STONEBOROUGH 3RD ADDITION

RE: S/D 00-16 -- One-Step Final Plat of STONEBOROUGH THIRD ADDITION

RE: S/D 00-16 -- One-Step Final Plat of STONEBOROUGH THIRD ADDITION

CASE NUMBER: S/D 00-16 -- STONEBOROUGH 3RD ADDITION

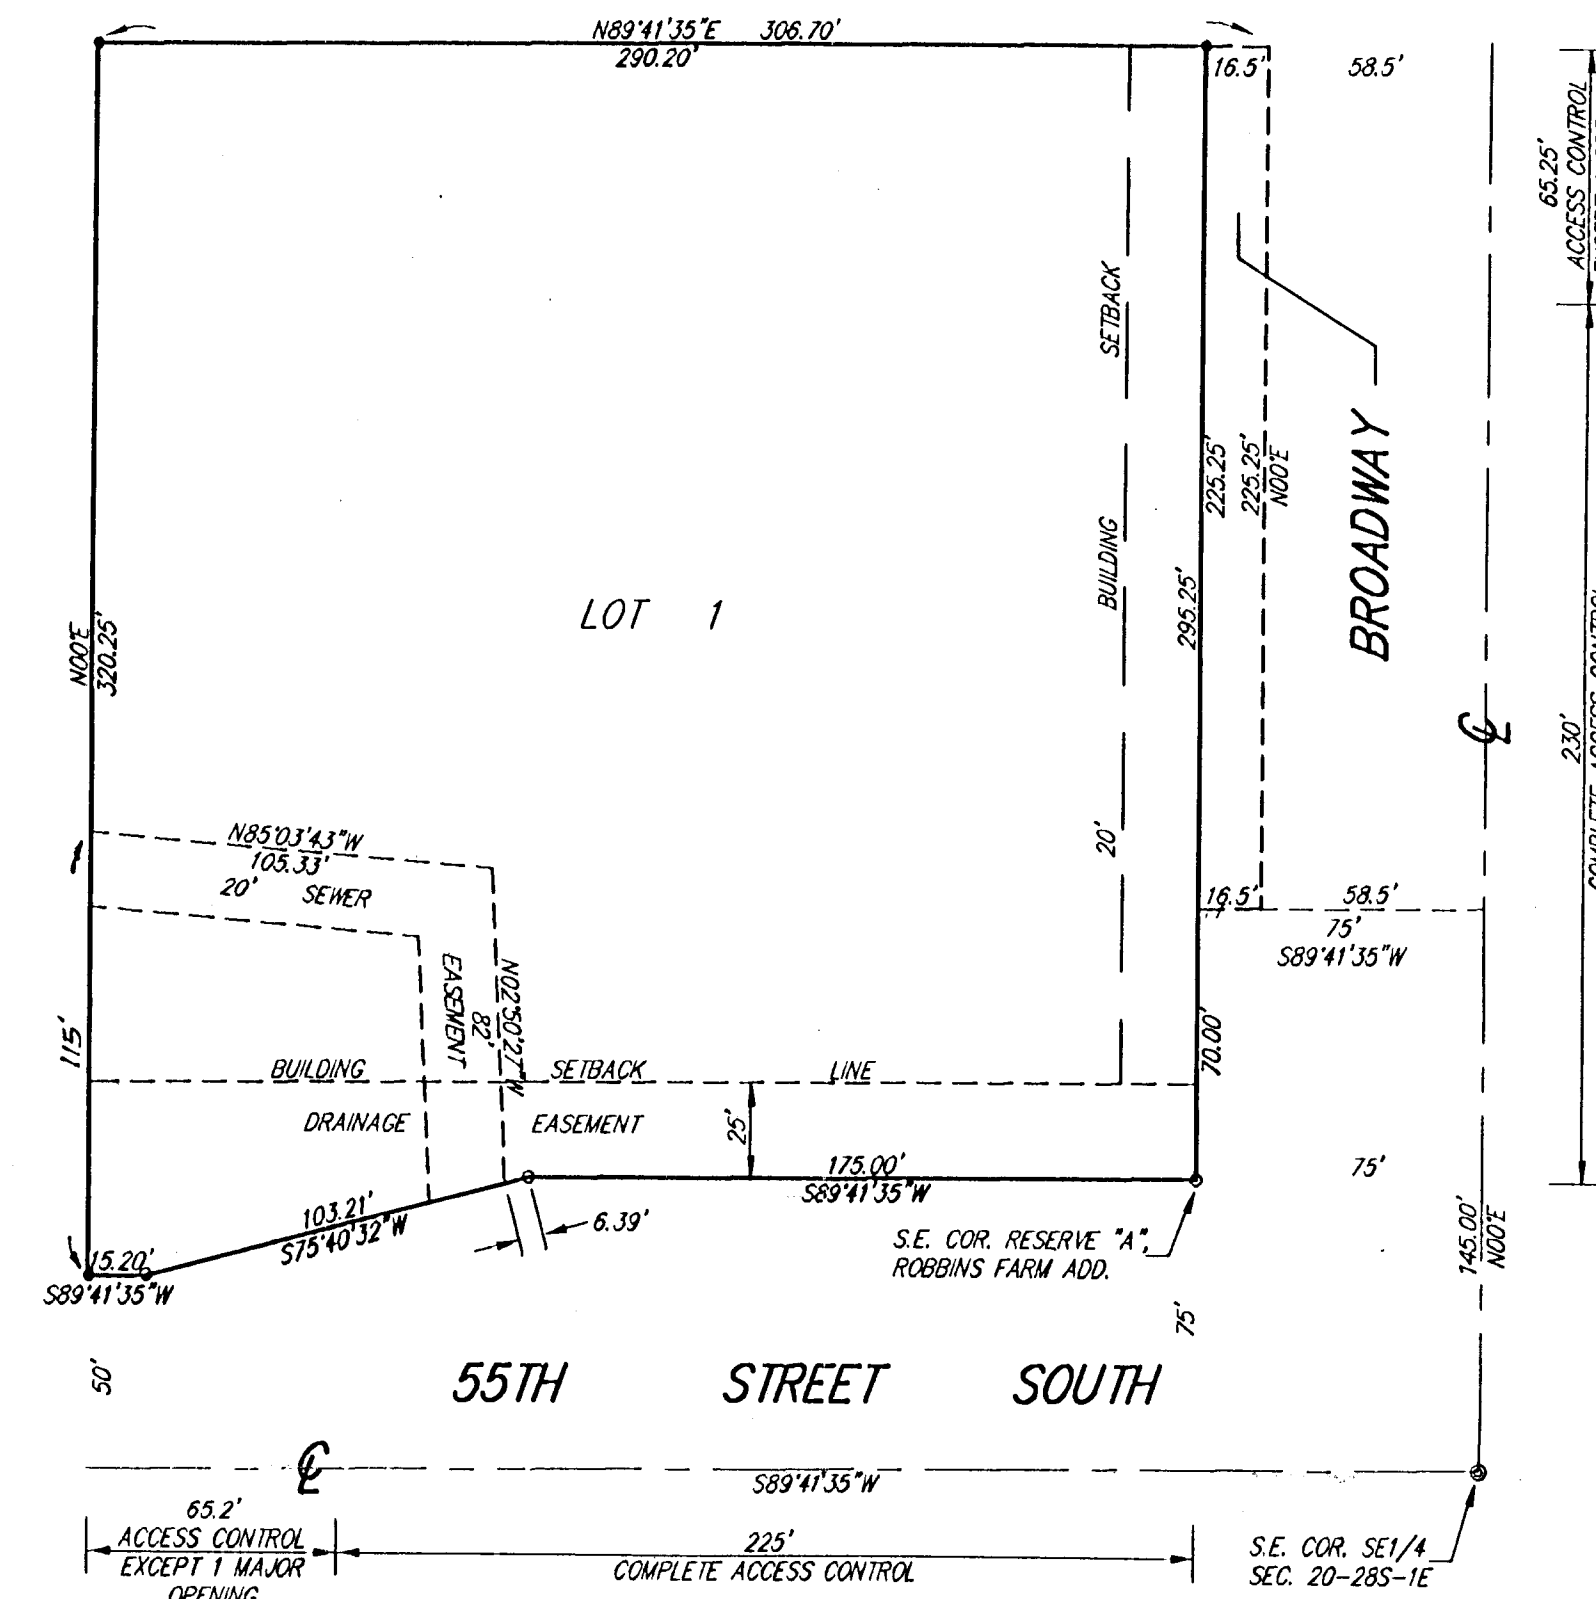
- A. Existing municipal services are available to serve the site. City Engineering needs to comment on the need for guarantees or easements. A drainage guarantee is required.

- C. City Engineering needs to comment on the status of the applicant's drainage plan. The drainage plan is approved. A drainage guarantee is required.

- D. Traffic Engineering needs to comment on the access controls and the need for alignment of the opening on 55th St. South with the opening to the south. The plat proposes one access opening on Broadway along the north property line and one access opening on 55th St. South along the west property line. Distances shall be shown for all segments of access control.

- G. If platted, the building setback may be a minimum of 20 feet, to conform with the GC District zoning requirement.
- H. The platlor's text shall include language that a drainage plan has been developed for the plat and that all drainage easements, rights-of-way, or reserves shall remain at established grades or as modified with the approval of the applicable City or County Engineer, and unobstructed to allow for the conveyance of stormwater.

- P. The representatives from the utility companies should be prepared to comment on the need for any additional utility easements to be platted on this property. *Southwestern Bell requests additional easements.*

"Traffic Engineering has approved the proposed access controls."
